SHOP DRAWINGS — ELECTRICAL / AGL SCOPE

RECTIFICATION OF TWY E BETWEEN E4 & E6 (ADIA)
AGL WORKS AT THREE (3) MILLING LOCATIONS — FIELD CONDITION SCOPE

Document No.	[XXX-ELE-SHD-1001 / 1002 / 1003] · Revision P06 (EDITABLE ISSUE)
Basis of scope	Field verification sheets: Document_3 (LOC-01) · Second_milling_area rev _1 (LOC-02/03) · Duct geometry: ADA drawing Z1-Z2-Z3-MTA_SEGMENTATION.dxf
Base layer	As-built AGL fitting positions (per assets_20260726120533.xlsx). AS PLOTTED they are ZIA LOCAL PROJECT GRID (m), matching the ADA source drawing to sub-millimetre — NOT UTM 40N. The Rev P05 EPSG:32640 label was incorrect — see sheet 6.
Prepared by	Mohammed — AGL Team Leader, ADB SAFEGATE AGL Team · Issued 28.07.2026

REV P06 — the "indicative duct" construction lines of Rev P05 (straight lines from each light to its nearest pit) are removed and replaced with the real as-built duct, ductbank, conduit and sawcut geometry from the ADA source drawing, registered onto each sheet to sub-millimetre. Every element remains a native editable PowerPoint shape. Provenance, registration residuals and limits: sheet 6.

LOCATION 3 — 1003 · REV P06 (EDITABLE)

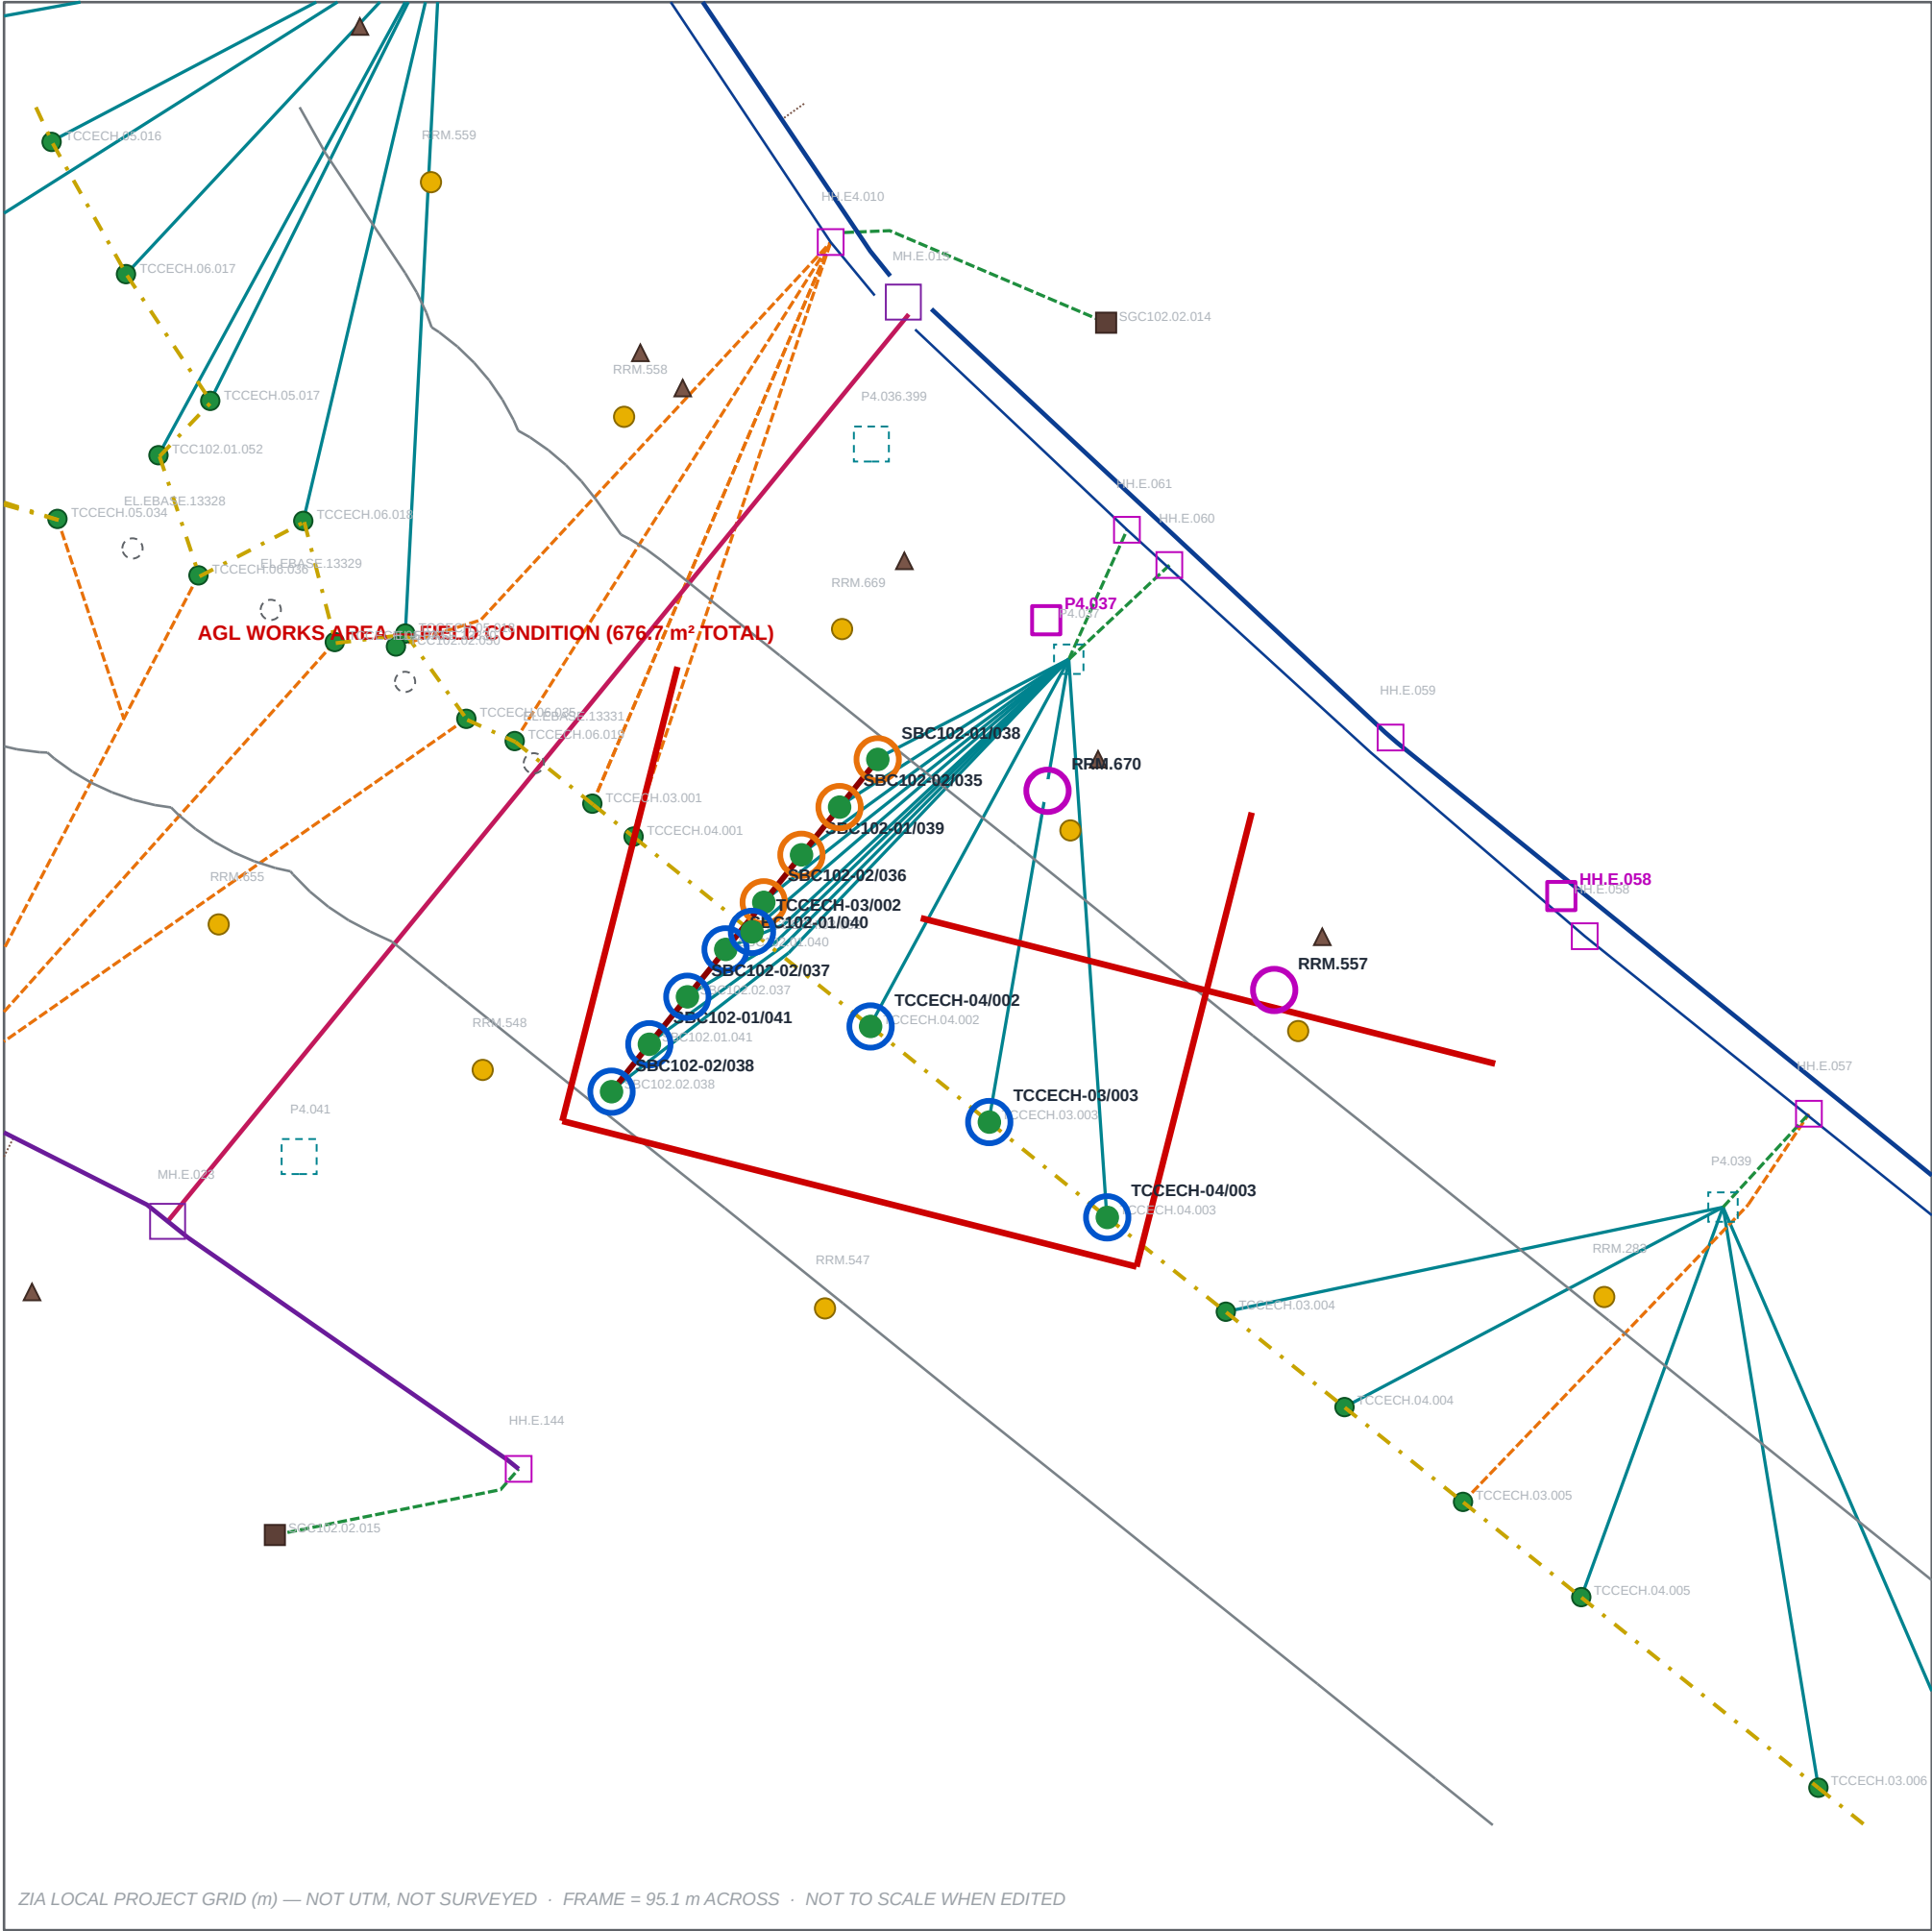
NO CORING AT THIS LOCATION — SECONDARY CABLES ONLY (12 RUNS)
NEW CABLE VIA SAWCUT: 4 No. — SBC102-01/038, 01/039, 02/035, 02/036
(EP7 STOP BAR — bases per field rev _1: remove fitting & protect base, NO coring)
NEW SECONDARY CABLE ONLY (VIA DUCT): 8 No.
• SBC102-01/040, 01/041, 02/037, 02/038, TCCECH-03/002, 04/002, 03/003, 04/003
RRM.557 (0.07 m — treat as within works) & RRM.670: REMOVE / PROTECT / RE-FIX
ISOLATE CIRCUITS: SBC102.01/02, TCCECH.03/04

6 · THE GEOMETRY, IN THE SOURCE DRAWING'S OWN GRID

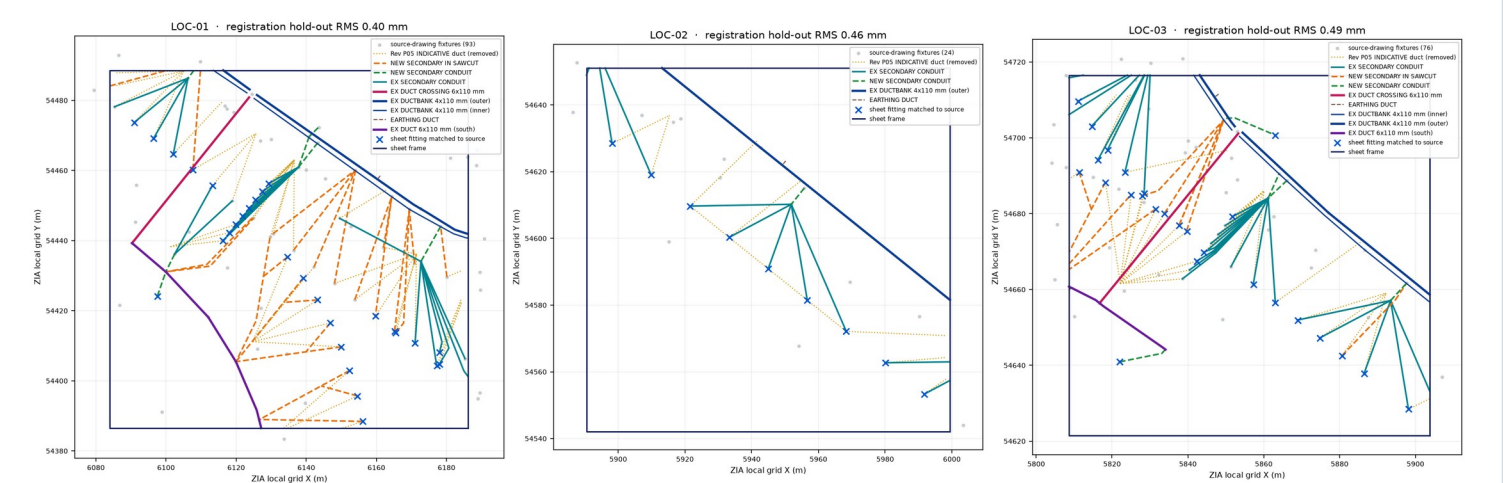
The sheets carry no coordinate grid, so each was registered to the source drawing by matching the plotted AGL fitting pattern: type-matched 2-point RANSAC to find the correspondence, then a 4-parameter Helmert fit (translation, rotation, uniform scale) by least squares — not an affine, which would hide error as fake shear. Half the matched pairs were held back from the fit; the hold-out RMS below is the accuracy figure.

Rotation solved to +0.0001° / −0.000001° / +0.0027° and the y axis is mirrored — i.e. the sheets are plotted axis-aligned to the grid.
Independent check: the deck's own "as-built taxiway centreline" polyline, never used in the fit, lands on source centreline fixtures at 0.3–0.4 mm median on LOC-01/02.

Rev P05 sheets state "UTM 40N (EPSG:32640) — AS-BUILT POSITIONS". They are not UTM. The plotted positions are ZIA local project grid metres (X ≈ 5,800–6,200, Y ≈ 54,400–54,700). UTM 40N here would read easting ~230,000–800,000 and northing ~2,650,000–2,750,000.
The source drawing carries no GEODATA object and no georeferencing of any kind, so no local→UTM transform can be derived from it. Rev P06 sheets are relabelled accordingly.
Consequence: any coordinate previously issued from Rev P05 as UTM — to ADA, Injaz or a contractor — needs withdrawing and re-checking against survey control.

- a) Runs are fragments, not proven pulls. The duct lines are the individual LINE / LWPOLYLINE segments as drafted. No endpoint snapping or graph chaining has been done, so "handhole A to handhole B" is not established. Do not order cable to a length scaled off these sheets.

- c) Civil symbols are ~2.1–2.3 m off. Handhole, manhole, transformer-pit and RRM symbols on the sheets sit a mean 2.1–2.3 m (sd 0.3–0.45 m) from the source-drawing insertion point, while AGL light fittings match to sub-millimetre. Set out civil features from survey, not from these sheets.
